Intersection ID: 44300	Main Street: ROCKWOOD_RD	Cross Street: CRANDON_DR	Location:	SW
ADA ID: AA3EBDB35A99	Ramp Type: BlendTrans1	Initial Pass/Fail: Fail	Overall Compliance: No	Severity Score: 18.75

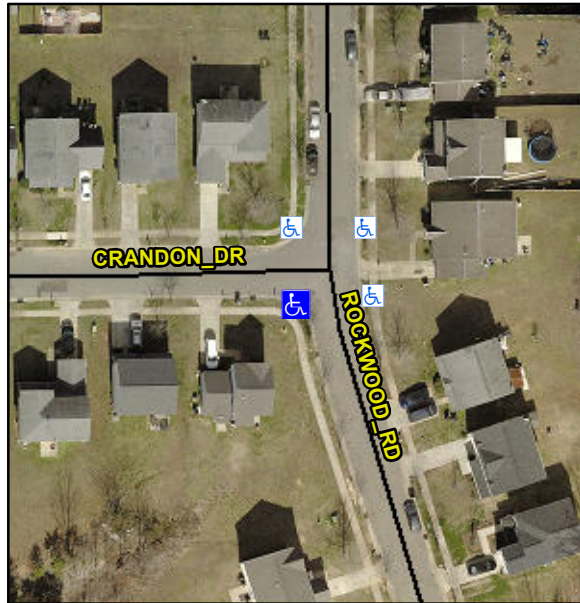
Not Found, R304.5.1, R304.5.3

Compliance	Description	Data	Compliance	Description	Data
N/A	Ramp Length (in)	53.0	Yes	BlendTrans Slope (%)	3.1
No	Ramp Width (in)	35.5	No	BlendTrans XSlope (%)	2.2
N/A	Flare Type LT	N/A	N/A	Flare Type RT	N/A
N/A	Flare Slope LT (%)	N/A	N/A	Flare Slope RT (%)	N/A
N/A	Flare Traversable LT?	N/A	N/A	Flare Traversable RT?	N/A
N/A	Landing Length (in)	N/A	N/A	DWS Provided?	N/A
N/A	Landing Width (in)	N/A	N/A	DWS Contrast?	N/A
N/A	Landing Slope (%)	N/A	N/A	DWS Length (in)	N/A
N/A	Landing X Slope (%)	N/A	N/A	DWS Full Width?	N/A
N/A	Landing Curb? (Y/N)	N/A	N/A	DWS Offset (in)	N/A
N/A	Shared Landing?	N/A			
N/A	Gutter Ponding?	N/A	N/A	Gutter Slope (%)	N/A
N/A	Gutter Lip Ht (in)	N/A	N/A	Gutter X Slope (%)	N/A
N/A	Painted X Walk1?	No	N/A	Painted X Walk2?	No
	X Walk 1 Direction	To E		X Walk 2 Direction	To N
	X Walk 1 Width (in)	N/A		X Walk 2 Width (in)	N/A
	X Walk 1 Slope (%)	4.5		X Walk 2 Slope (%)	3.8
	X Walk 1 X Slope (%)	1.8		X Walk 2 X Slope (%)	3.0

N/A	Ramp inside XWalk1?	N/A	N/A	Ramp inside XWalk2?	N/A
	Road Slope (%)	0.1		Clear Space?	N/A
	Road X Slope (%)	6.1	N/A	Clear Space to XWalk (in)	N/A
N/A	Any Obstructions?	N/A	N/A	Storm Grate/Utility Hazard?	N/A
	Obstruction Type			Storm Grate/Utility Type	
		N/A			N/A
			Yes	Surface Condition? (G/P)	Good
			No	Curb Slope (%)	12.9

Remove & Replace Curb Ramp With Two New Directional Ramps or Equivalent.
